UNITED STATES PATENT AND TRADEMARK OFFICE

APPLICATION NO.	FILING DATE	FIRST NAMED INVENTOR	ATTORNEY DOCKET NO.	CONFIRMATION NO.
10/600,379	06/20/2003	Steve B. Taylor	2236.001	7549

Office Action Summary

DETAILED ACTION

Patent 5697320 (see marked-up figures below).

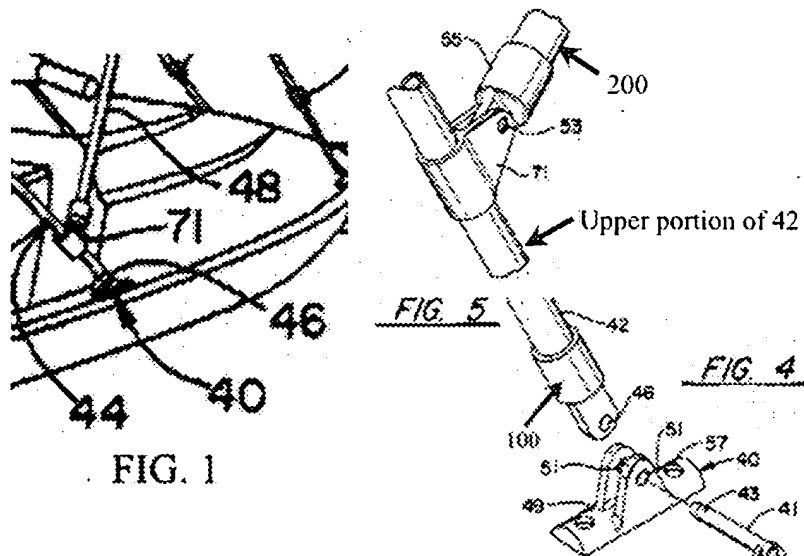
Claims 1-3 are rejected under 35 U.S.C. 102(b) as being anticipated by Murray U.S.

Claim 1. Murray discloses (figs. 1, 4, 5) a variably positionable coupler mountable on a curved surface, comprising: a base (40) formed with an upper side and a lower side, wherein the lower side is a substantially flat planar surface; means (57) for mounting the base on the curved surface (curved surface of the watercraft as seen in figure 1); a tub (100) adjustably connectable

Claim 2: Murray discloses opposing yokes (tab portions of 40 receiving 41) monolithically extending at substantially right angles from the upper side of the base.

Claim 3. Murray discloses one or more bores (51) formed in the base with a proximal end and a distal end, and further wherein the one or more bores are shaped for removable engagement with a bolt (41). The word "bolt" is taken by the Examiner to mean, "a metal rod or pin for fastening objects together" in accordance with Merriam-Webster's Collegiate Dictionary Tenth Edition.

The applicant argues that the Murray elements, as referred to by the examiner in the marked-up drawings above, do not read upon that applicant’s claims because the elements of figure 4 and figure 5 do not form a connected assembly. This is not persuasive. Note that Figure 5 is a close-up depiction of an area of figure 1 near element 71. Further note that Figure 4 is a close-up depiction of an area of figure 1 near element 40. As clearly shown in figure 1, the element 71 area is directly above and connected to the element 40 area. Thus, the elements of figure 5 are directly above and connected to the elements of figure 4.
